CITY COUNCIL AGENDA ITEM COVER SHEET

Subject: Adams Creek Cohousing Site Plan Review, File No. 2020-03
Appeal of Planning Commission Decision

This matter comes to City Council on an appeal by opponents of the Planning Commission's Site Plan approval to construct a multi-family cohousing development consisting of 26 dwelling units in 3 buildings, two common buildings, a parking lot, carport, pathways and walkways, street frontage improvements, and associated site improvements. See Packet pp 36-586 (the PC's decision). The opponents' appeal statement raises 15 appeal issues challenging the Planning Commission decision, most of which assert that the application and record lack sufficient information, plans and detail to approve. See Packet pp 26-33 (the opponents' appeal).

DRAWING NO. **C6**

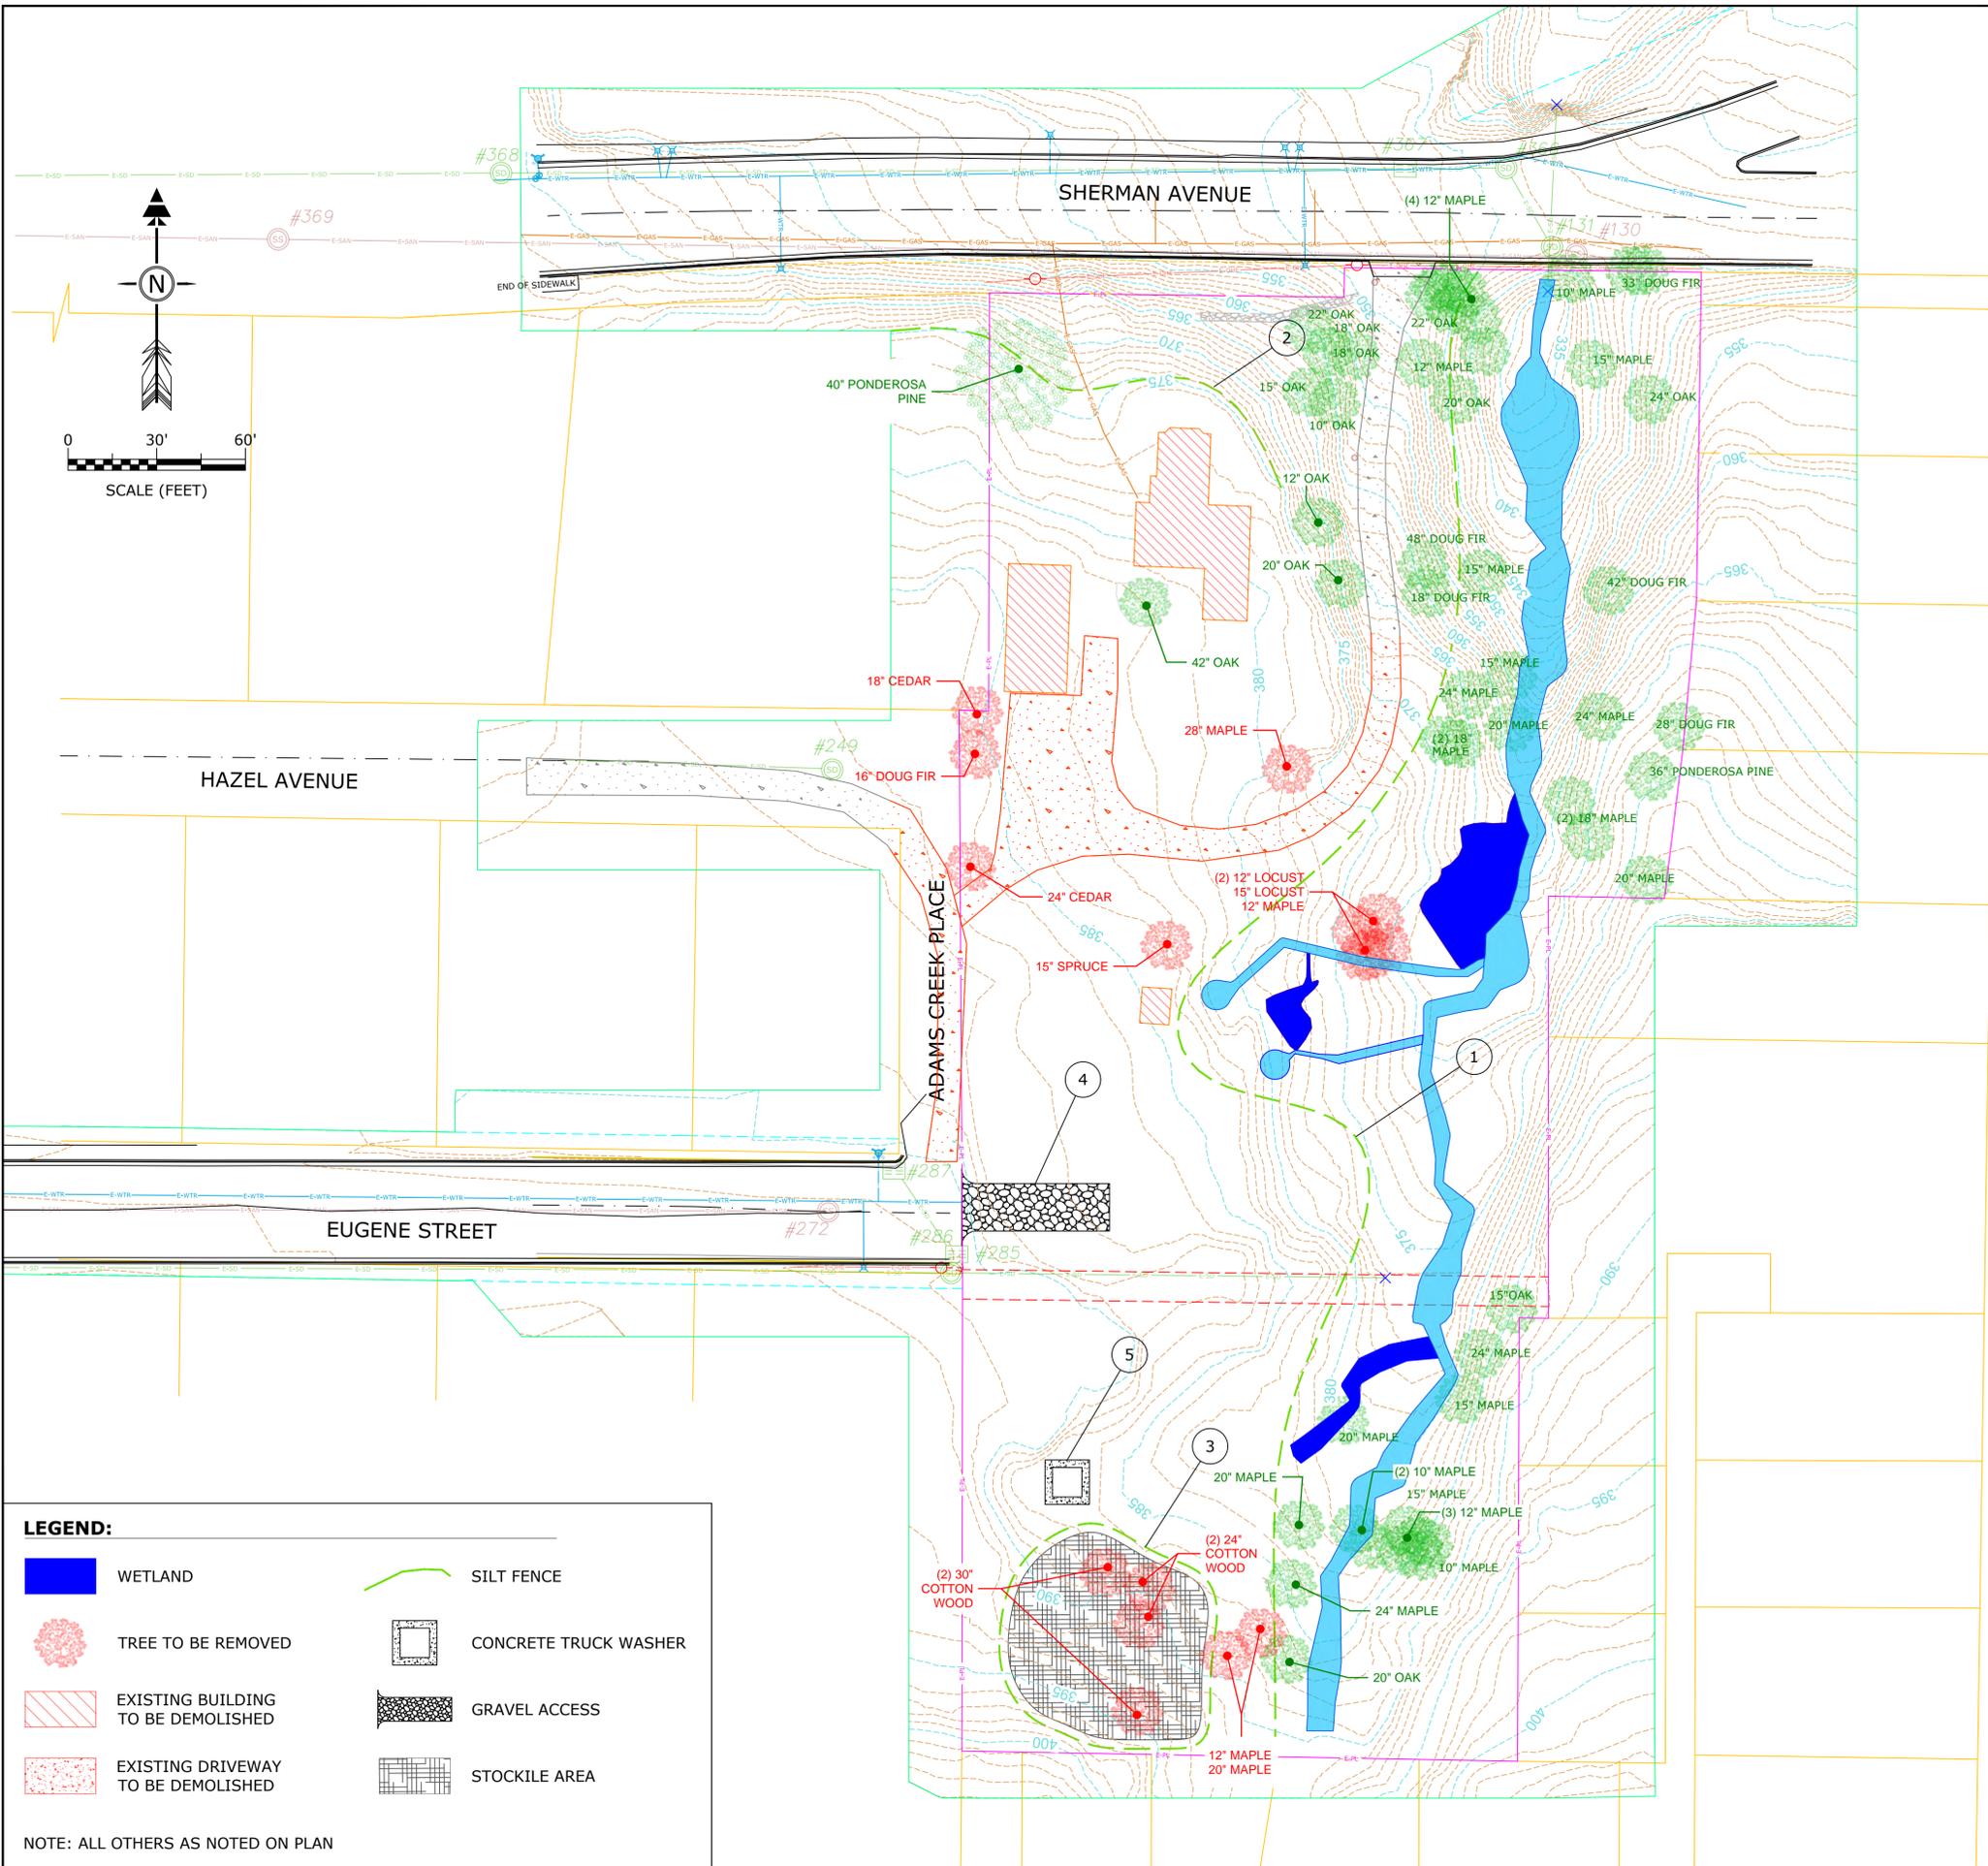
- Location and species of trees greater than 6” in diameter (subsection 9): What appear to be the larger trees are shown on the Existing Conditions map (Sheet C-6). (Note: The green symbols are not shown in the legend). While there appear to be more than 40 “large” trees on the site, Applicant does not identify the species or size of any of them.
